**PROJECT: Multi-Sport Venue in Eastern New Orleans and Lower Ninth Ward
4290 Almonaster Avenue,
New Orleans, LA 70126**

ADDENDUM NO. 2

OPSB Project No. ITB 26-FAC-0053

January 23, 2026

1 | SITE PLAN ENLARGEMENT - NORTH
 E102 | SCALE: 1/32" = 1'-0"

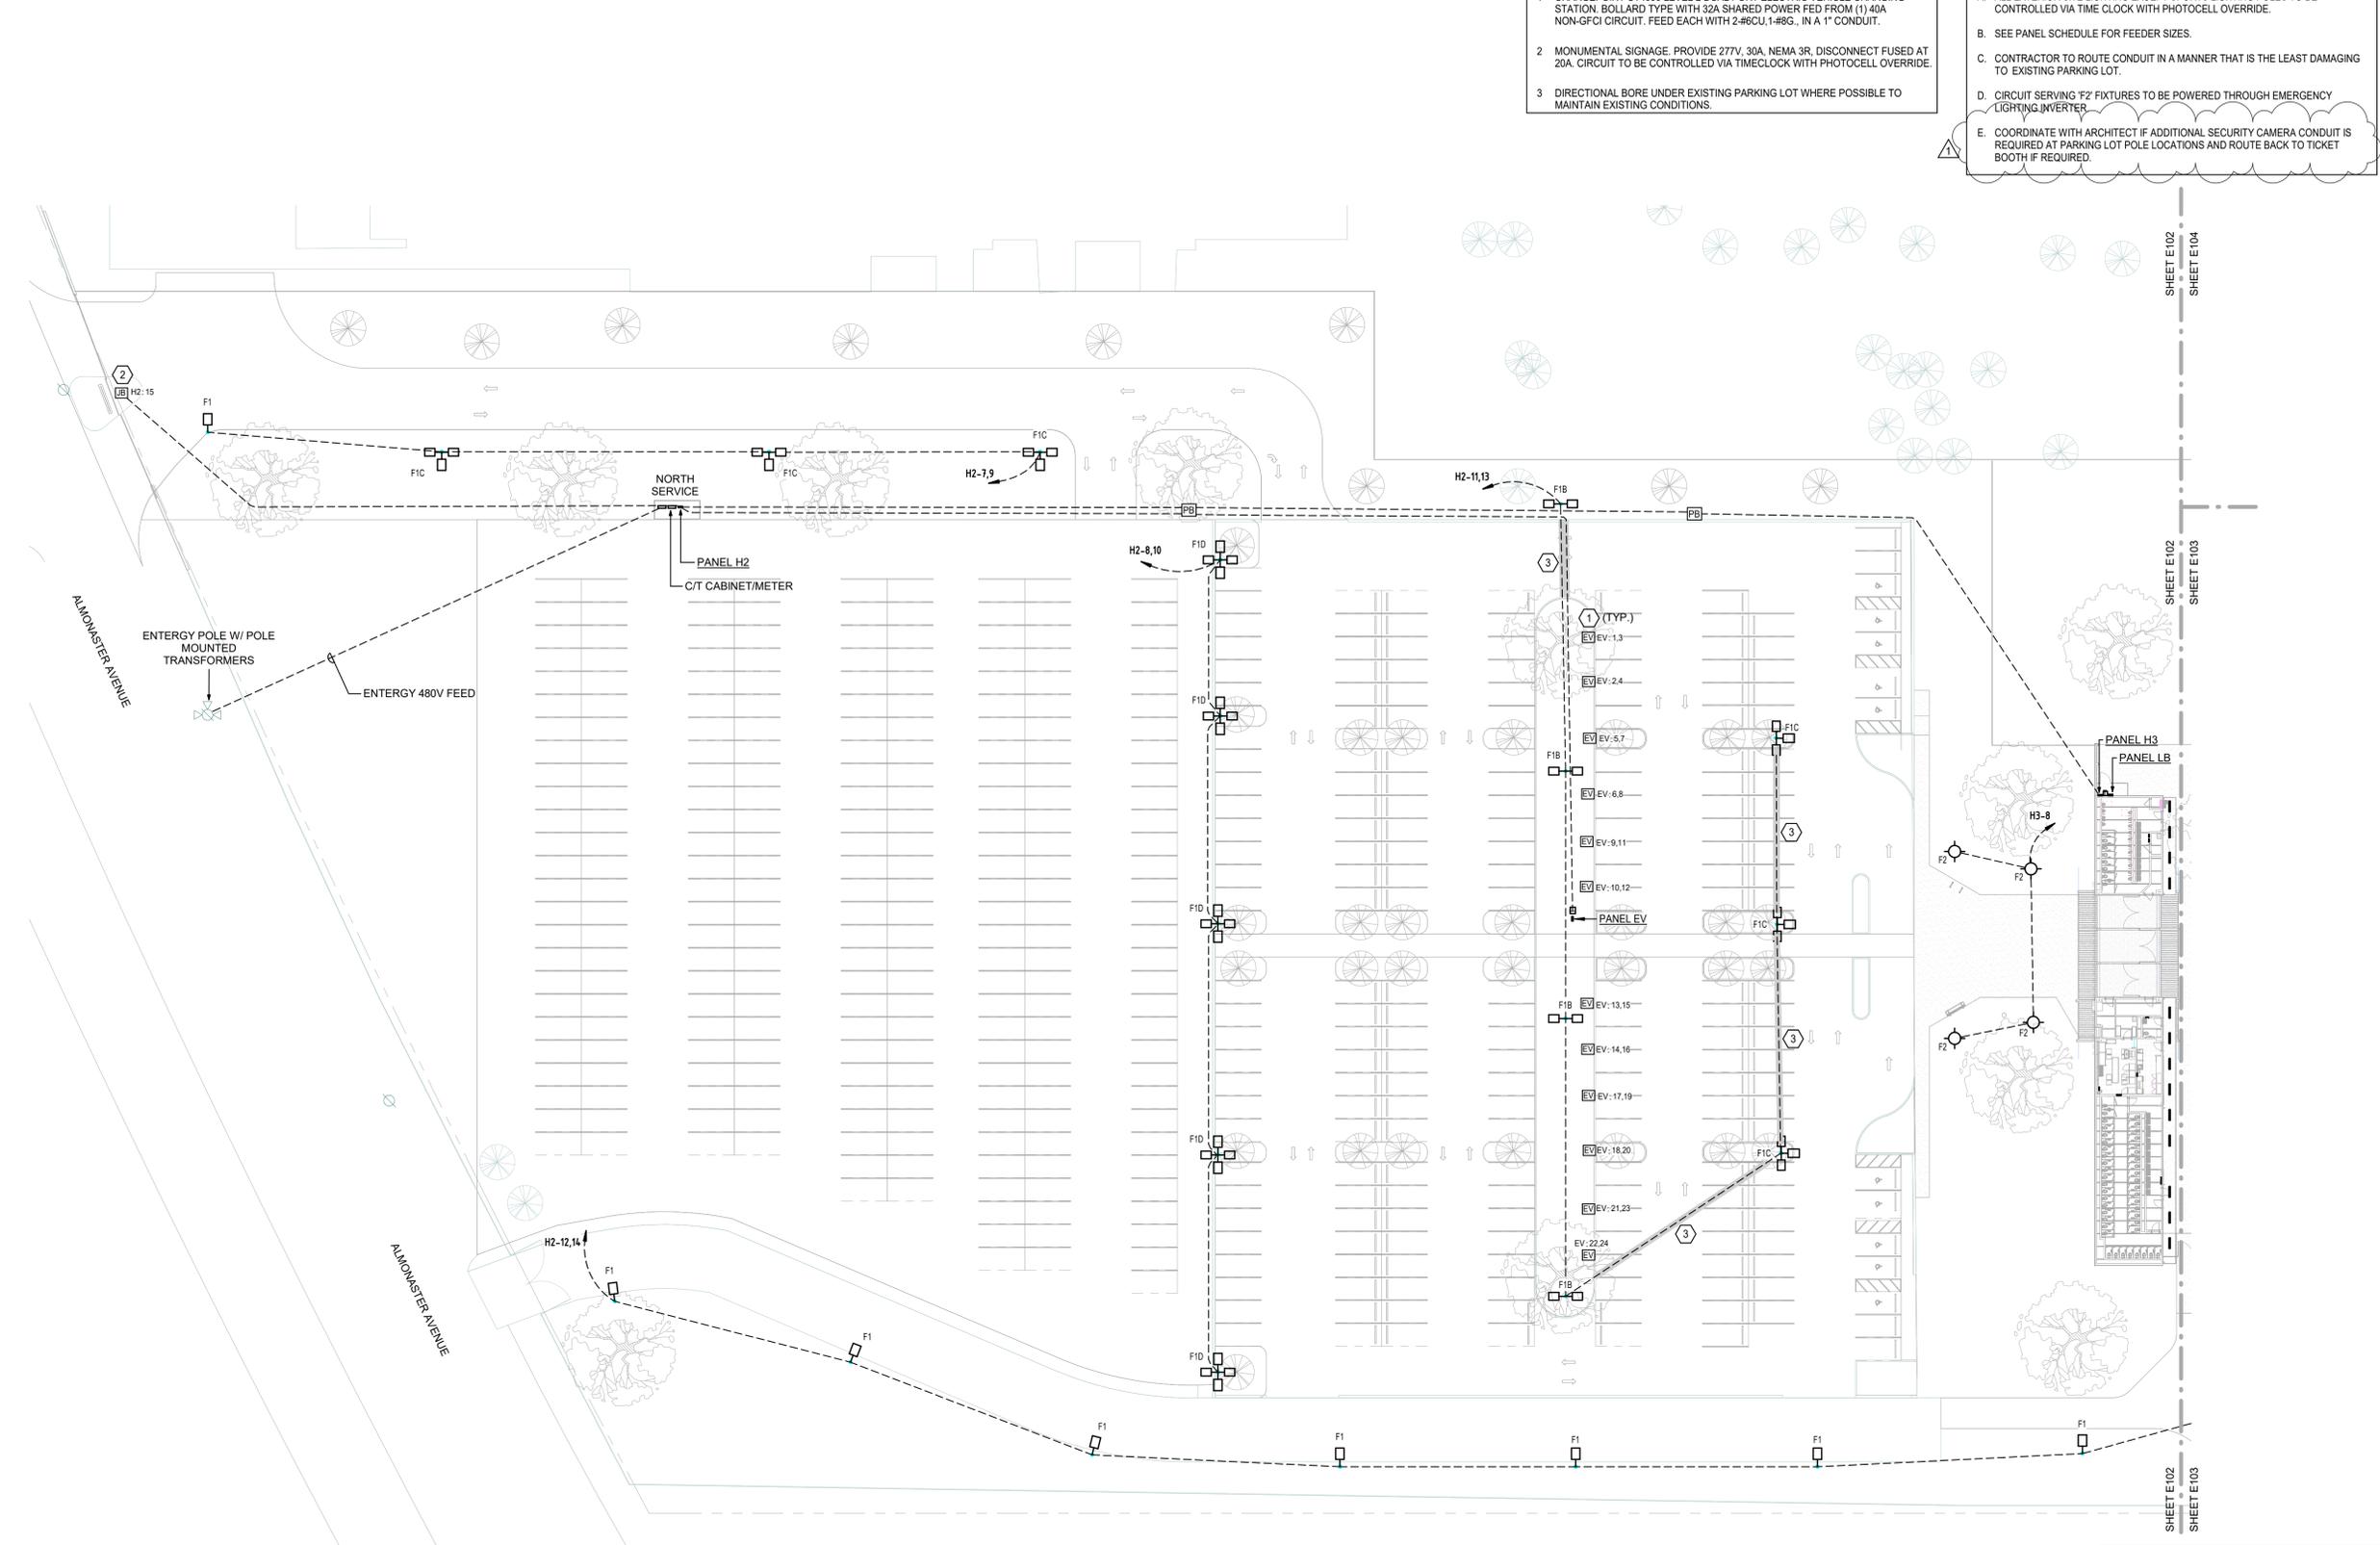
7. Clarification of security camera conduit locations are provided on sheet E102, Sheet General Notes, note E.
8. Wall pack lighting is provided on the west side of the north and south buildings, shown on the lighting plans on sheet E200 and E201.

1 | SITE PLAN ENLARGEMENT - SOUTH WEST
E103 | SCALE: 1/32" = 1'-0"

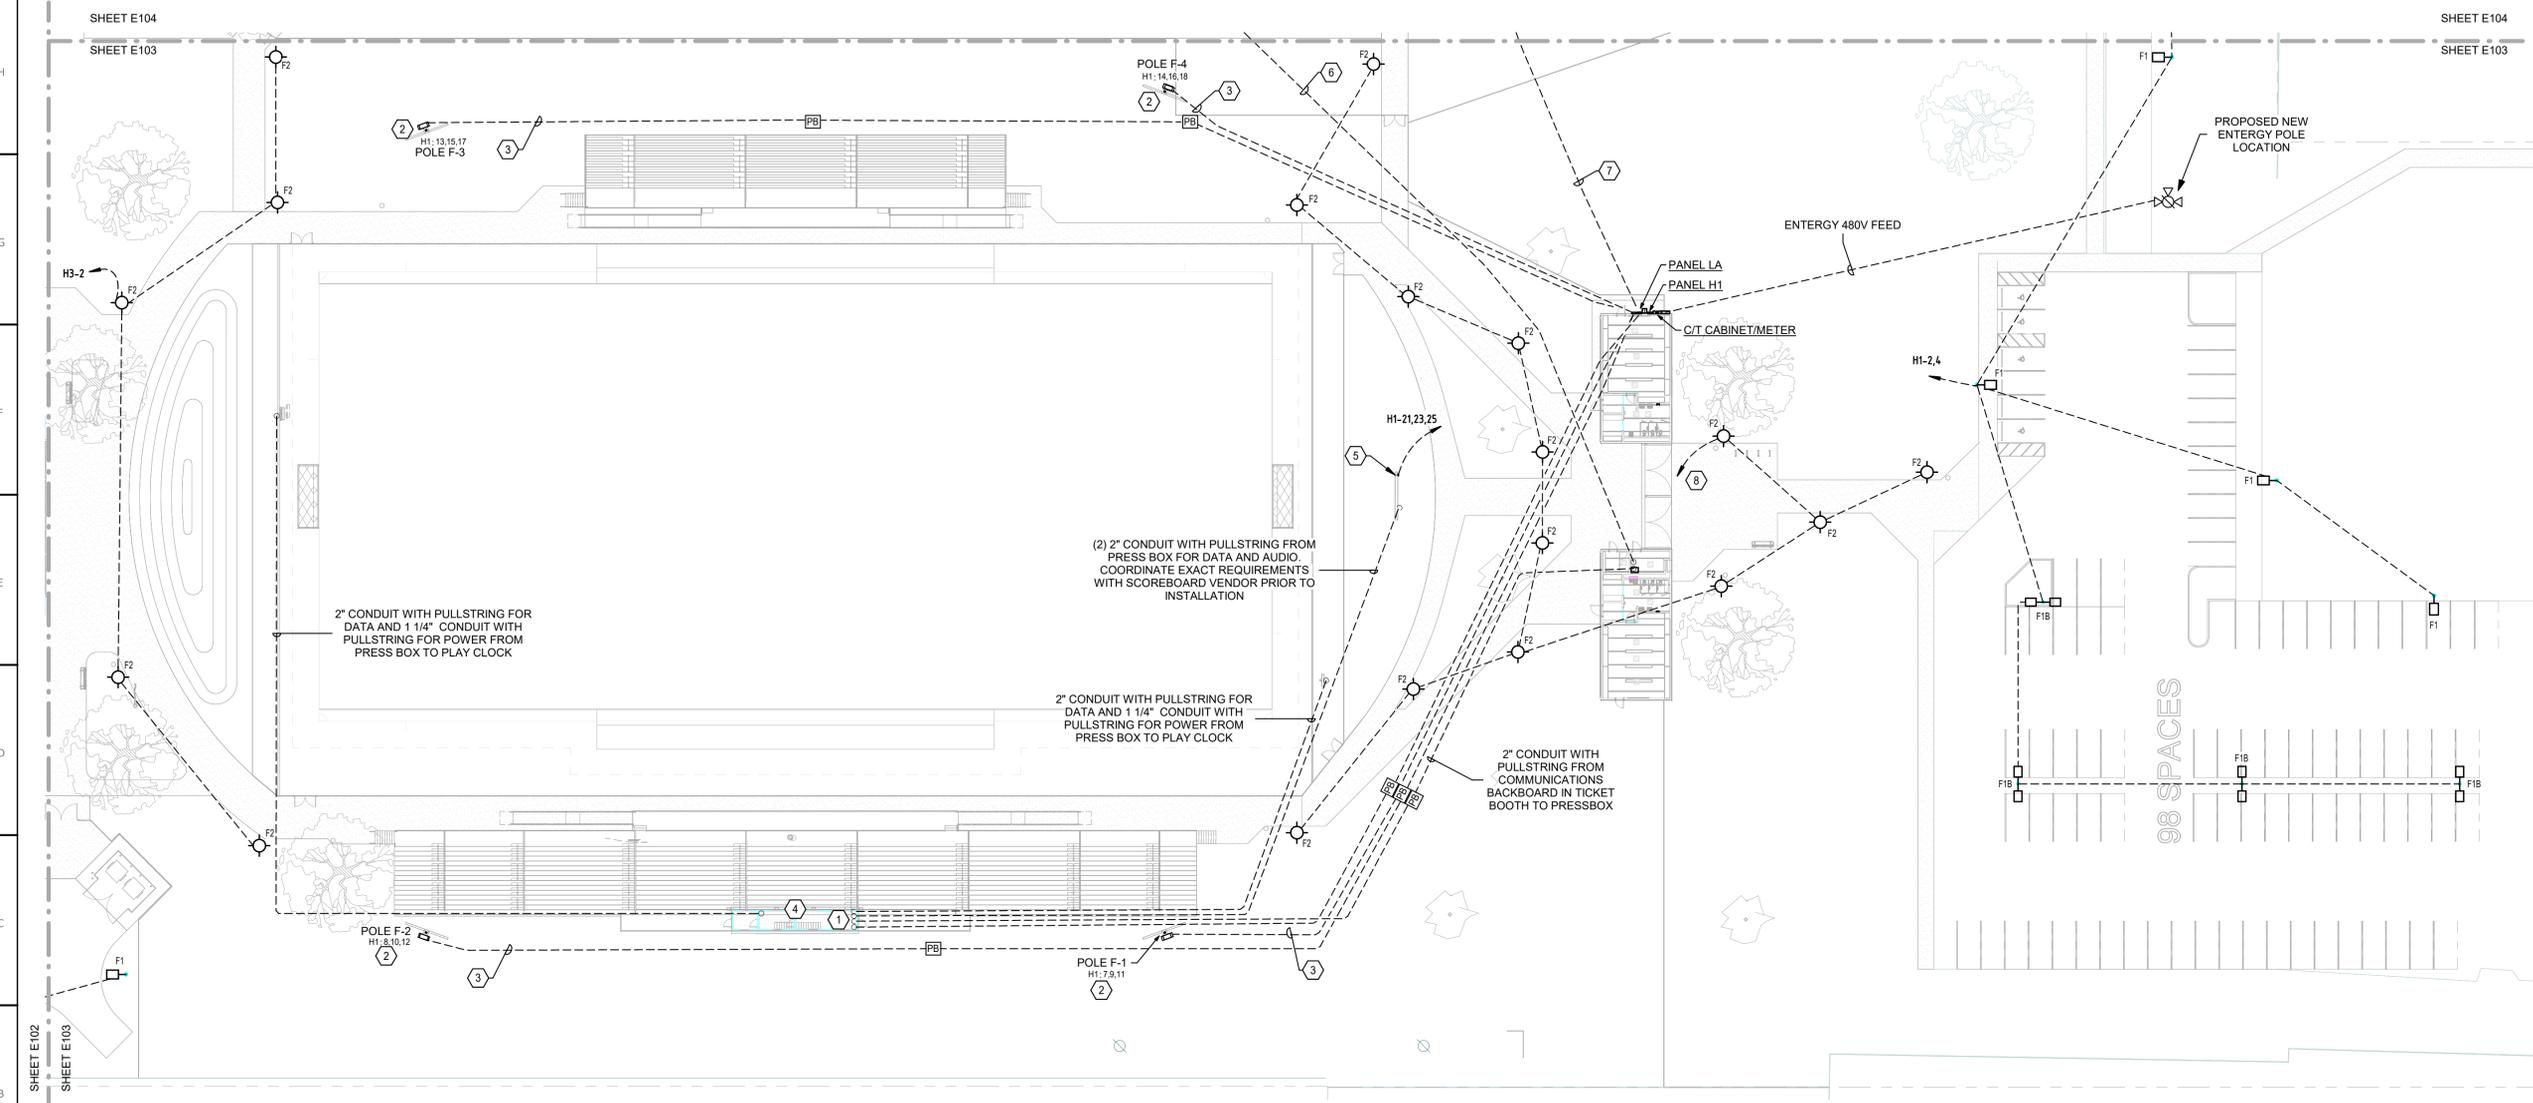
Response: Additional information for the PA system is provided on sheet E103, Sheet Reference Notes, note 4.
